UNITED STATES
NUCLEAR REGULATORY COMMISSION
WASHINGTON, D.C. 20555

Subject: Corrosion Effect on Re Bar

QUESTIONS ON WATERFORD 3 BASEMAT
3/26 MEETING IN BETHESDA

WATERFORD III BASE MAT

2-D FINITE ELEMENT MODEL

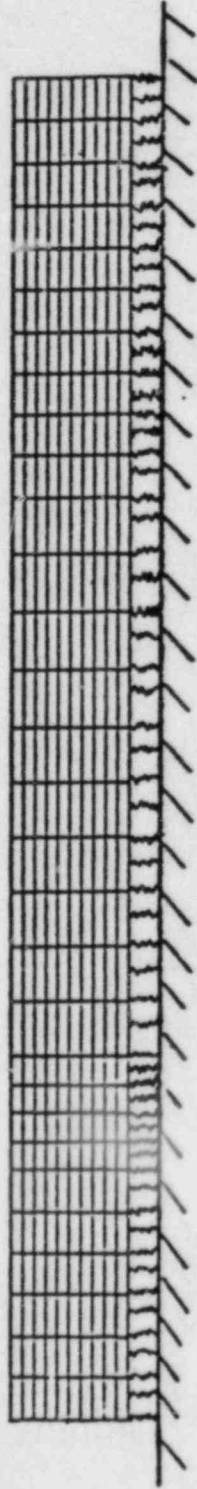
- 1042 NODES
- 300 PLANE STRESS ELEMENTS ($t = 288$ in)
60 ELEMENTS WITH REBARS.
- 61 SOIL SPRINGS
- 1961 APPLIED LOADS
- 123 BOUNDARY CONSTRAINTS
- MODELS WITH AND WITHOUT VOIDS

VOIDS WITH 5, 10 AND 15 PERCENT
RANDOM DISTRIBUTION
